Re: Ex Parte Presentation GEN Docket No. 90-314
RM-7140, RM-7175, RM-7618

**Docket 90-314 Second Report and Order
Unlicensed PCS**

Isochronous Sub-band

Multi Carrier Operation

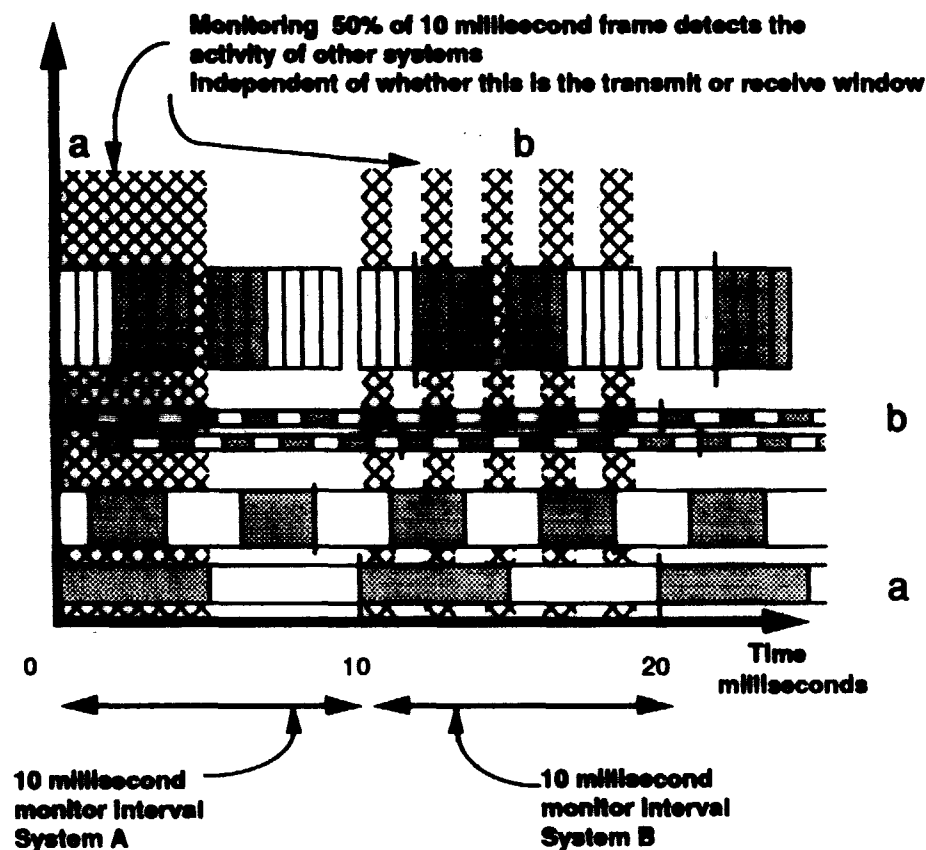
The requirement to monitor during the transmit interval means that when selecting an additional frequency channel, the device will hear mainly its own transmissions * (due to its currently active transmitters) and this will prevent the selection of additional frequency channels.

* for example with a +20 dBm transmitter power, 10 dB of isolation between transmitter and receiver and 70 dB of channel filtering, the receiver would expect to see -60 dBm as its monitored level which is well above the allowed access threshold of -84 dBm. An additional frequency channel could never be selected.

suggested multi carrier access provision

15.321 (c)(11) Before initiating transmission, devices which are prevented from monitoring during their intended transmit interval due to receiver blocking from the transmissions of a co-located (within one meter) transmitter of the same system, may monitor the portions of the time and spectrum windows in which they intend to receive over a period of a least 10 milliseconds to determine if the access criteria are met ~~so long as the monitored spectrum is within the 1.25 MHz frequency channel(s) already occupied by that device or co-located (within one metre) co-operating group of devices.~~ The receive monitoring interval must total a least 45% of the 10 millisecond interval.

Recommend removing the limitation to the same frequency channel proposed by WINTech in order to accommodate Wireless PBX air interface standard being proposed in TR41. Note that 15.321(c)(5) limits any device to no more than three 1.25 MHz frequency channels at once.

Duplex Operation

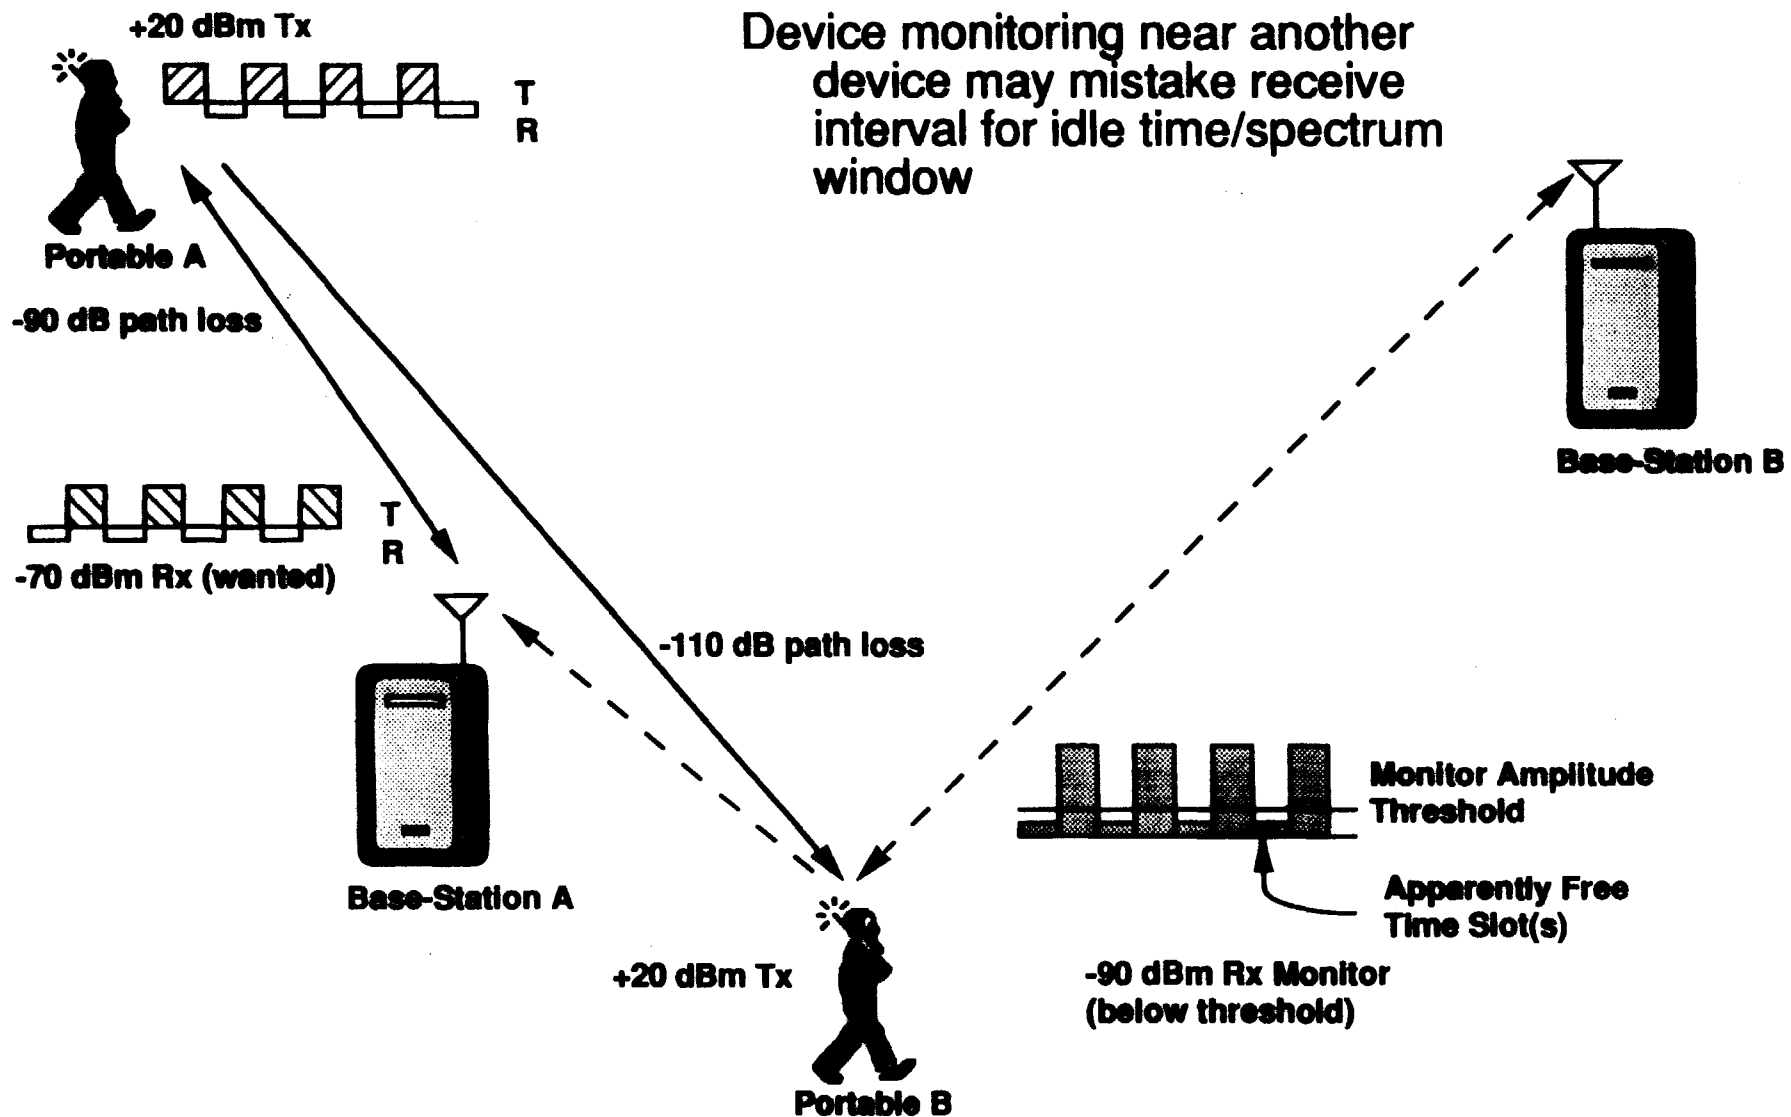
transmission on one time slot from base station implies a particular reciprocal slot from the portable

packing rule and lowest monitored channel rule may prevent the selection of the reciprocal pair at base and portable

15.321 (c)(10) An initiating device may attempt to establish a duplex connection by monitoring both its intended transmit and receive time and spectrum windows in accordance with 15.321 (c). Time and spectrum window access selection for the initiating device shall be based on the higher measured power of the intended transmit or receive time and spectrum windows. If the power detected by the responding device can be decoded as a duplex connection signal from an interoperable device (the initiating device), then the responding device may immediately begin transmitting on the receive time and spectrum window of the initiating device.

under this rule, a responding device would be allowed to use a reciprocal time/spectrum slot if the initiating device had monitored both transmit and receive time/spectrum windows and found them to be free
